April 12, 1984

Serial No. 201
NO/JDH:acm
Docket No. 50-281
License No. DPR-37

ASME XI RELIEF REQUEST
SURRY POWER STATION UNIT 2

ATTACHMENT 1

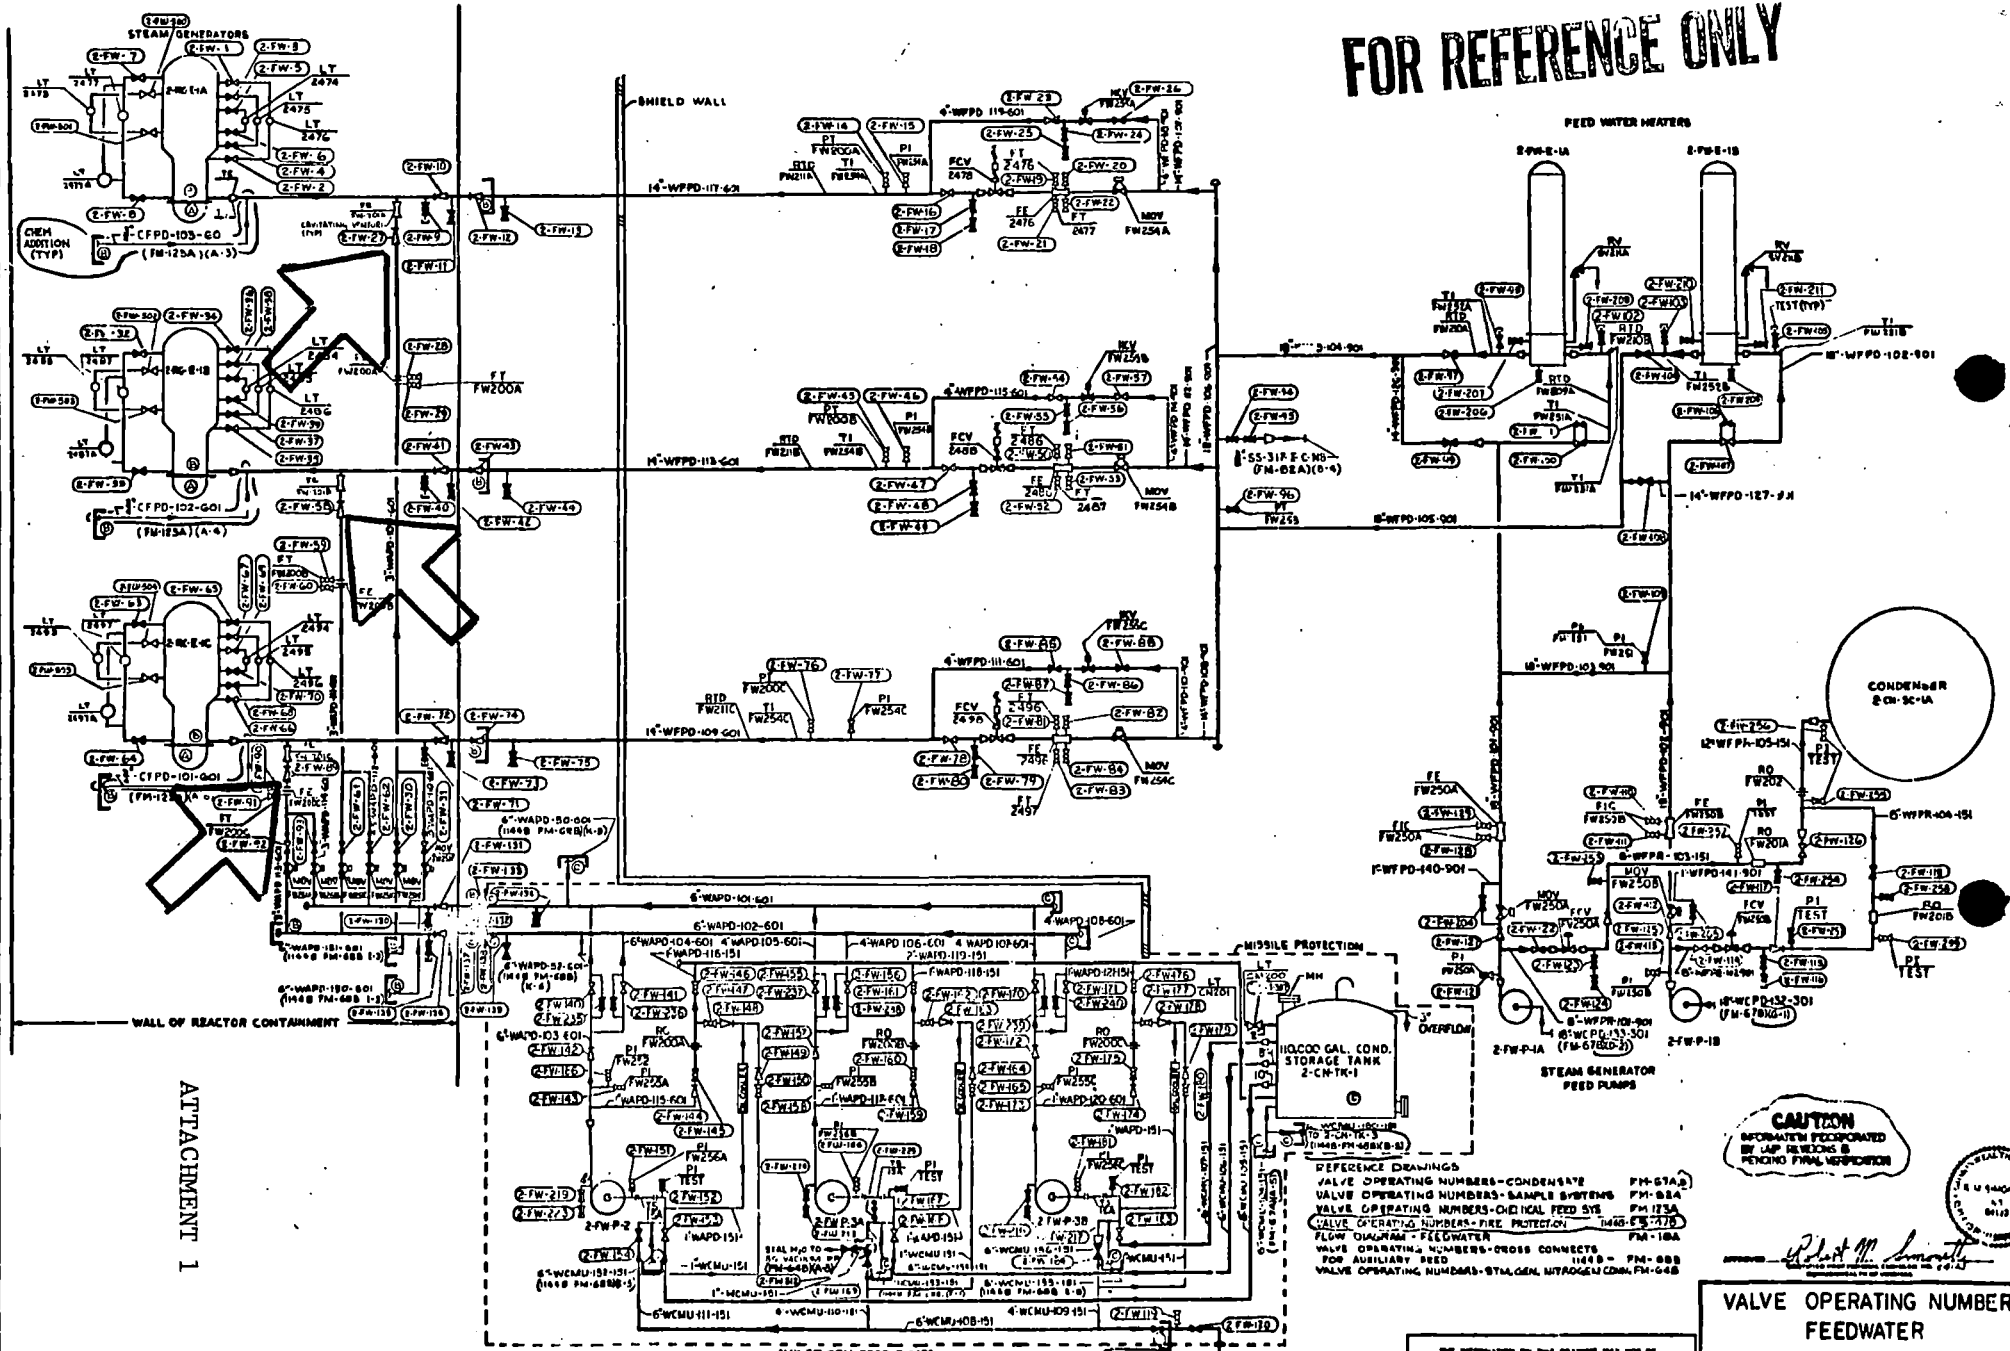
1. Due to check valve leakage three, 3 inch check valves, 2-FW-27, 58, and 89 (Attachment 1), are required to be removed and repaired utilizing the rules of IWA 4000, IWA 7000 and IWC 7000 of ASME Section XI, 1980 edition W 1980 addenda. This action as defined in IWA 5214 requires a hydrostatic pressure test in accordance with IWC 5222. As evidenced by the attached drawings, this hydrostatic test would include all three main steam generators and a significant portion of the attached feedwater and main steam piping. As this test is considered extremely difficult and impractical, alternative inspection is proposed.

Upon reinstallation of the attachment welds a surface examination (liquid penetrant) will be conducted. In addition, a radiographic examination will augment the post repair inspection in lieu of the required pressure test.

ATTACHMENT 2

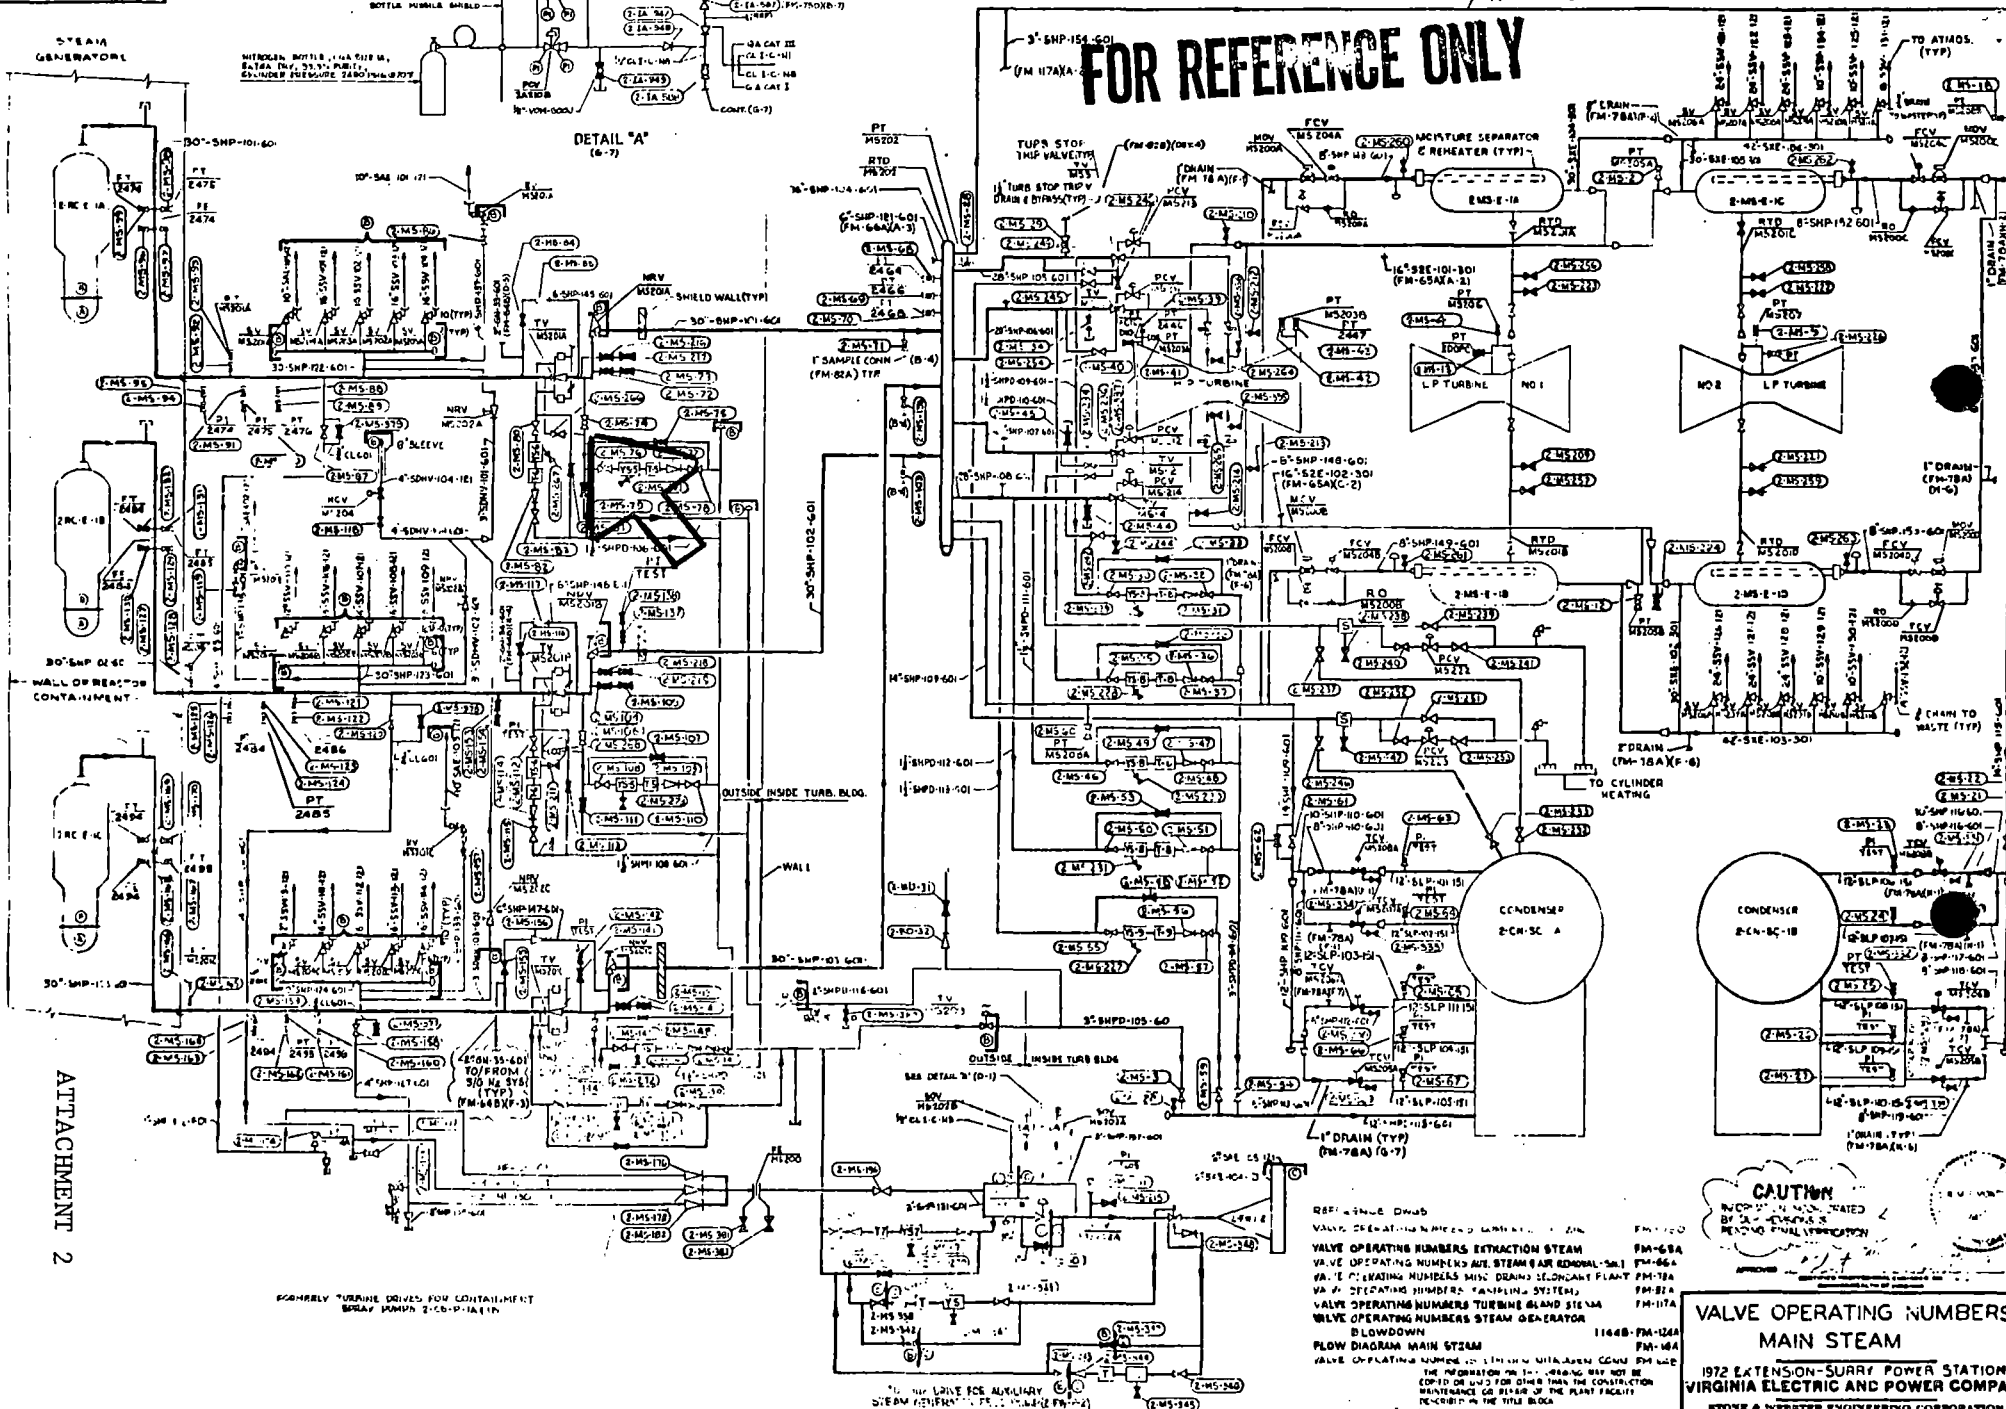
2. Due to internal leakage, a 1-1/2 inch manual isolation valve, 2-MS-74 (Attachment 2), requires replacement utilizing the rules of IWA 7000 and IWC 7000 of ASME Section XI, 1980 edition W 1980 addenda. This replacement as defined in IWA 5214 requires a hydrostatic pressure test in accordance with IWC 5222. This test, if conducted, would include within the hydrostatic test boundaries the 'A' main steam generator and a large portion of the associated piping. This test, as previously stated, is considered difficult and impractical. As a result, alternative inspection is proposed.

A surface examination (liquid penetrant) will be conducted on the attachment welds. In addition, a system pressure test (IWC 5221) in conjunction with a VT-2 examination will be substituted for the required hydrostatic test.
